City of Phoenix

Staff Report Z-53-22-8 (Gila Foothills PUD) February 12, 2024

Planned Unit Development to allow single and multifamily residential, commercial uses, and some commerce park

Other Recommended PUD Updates

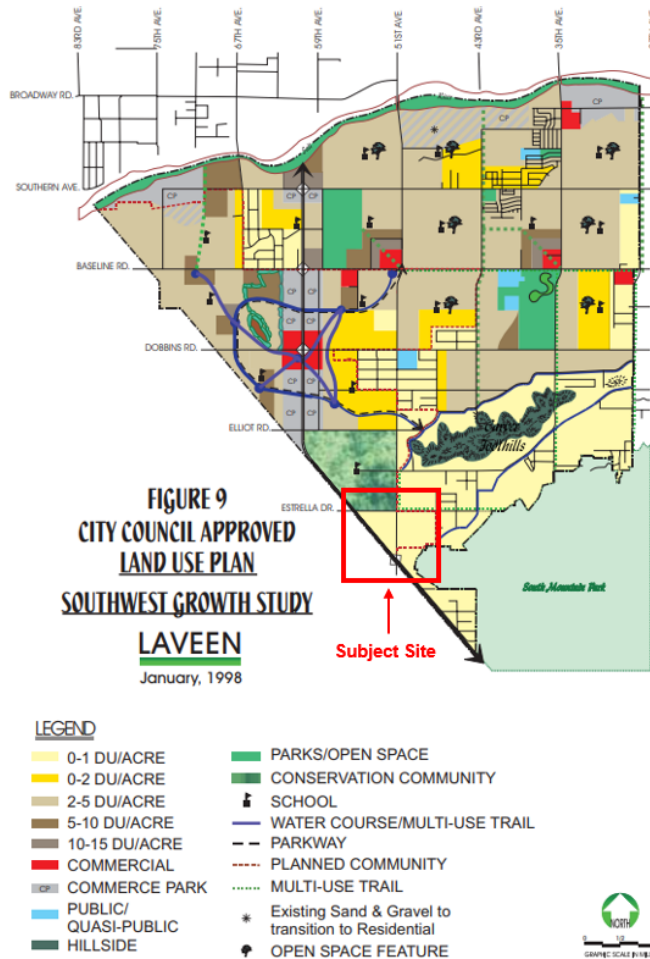
Staff recommend adding a provision for recycling as an option in the

Sustainability Section. This is addressed in Stipulation No. 1.cc.

...design to be presented for review and comment to the Laveen Village Planning Committee.
 - cc. Page 52, Section 6. Sustainability: Add a provision for recycling as the last bullet point.
